Access Compliance Report

Public Rights-of-Way

Intersection ID: 51370	Main Street: UNIVERSITY_POINTE_BV	Cross Street: IKEA_BV	Location: NW
ADA ID: F7C8EEC694BC	Ramp Type: PerpDiag	Initial Pass/Fail: Fail	Overall Compliance: No
		Severity Score: 25

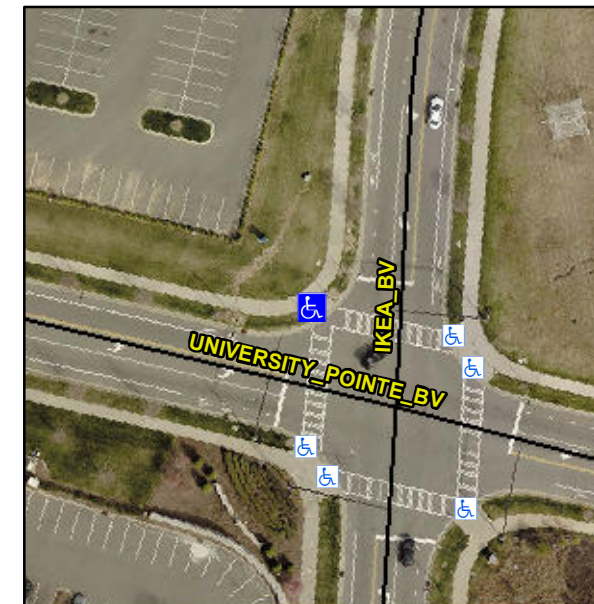
Not Found, R304.5.3

Compliance	Description	Data	Compliance	Description	Data
N/A	Ramp Length (in)	95.0	Yes	Ramp Slope (%)	7.7
Yes	Ramp Width (in)	59.0	No	Ramp XSlope (%)	11.3
N/A	Flare Type LT	N/A	N/A	Flare Type RT	N/A
N/A	Flare Slope LT (%)	N/A	N/A	Flare Slope RT (%)	N/A
N/A	Flare Traversable LT?	N/A	N/A	Flare Traversable RT?	N/A
N/A	Landing Length (in)	N/A	N/A	DWS Provided?	N/A
N/A	Landing Width (in)	N/A	N/A	DWS Contrast?	N/A
N/A	Landing Slope (%)	N/A	N/A	DWS Length (in)	N/A
N/A	Landing X Slope (%)	N/A	N/A	DWS Full Width?	N/A
N/A	Landing Curb? (Y/N)	N/A	N/A	DWS Offset (in)	N/A
N/A	Shared Landing?	N/A			
N/A	Gutter Ponding?	N/A	N/A	Gutter Slope (%)	N/A
N/A	Gutter Lip Ht (in)	0.5	N/A	Gutter X Slope (%)	N/A
N/A	Painted X Walk1?	Yes	N/A	Painted X Walk2?	Yes
	X Walk 1 Direction	To SE		X Walk 2 Direction	To S
N/A	X Walk 1 Width (in)	112.0	N/A	X Walk 2 Width (in)	112.0
	X Walk 1 Slope (%)	5.8		X Walk 2 Slope (%)	6.8
	X Walk 1 X Slope (%)	9.0		X Walk 2 X Slope (%)	7.2

Remove & Replace Curb Ramp With Two New Directional Ramps or Equivalent.
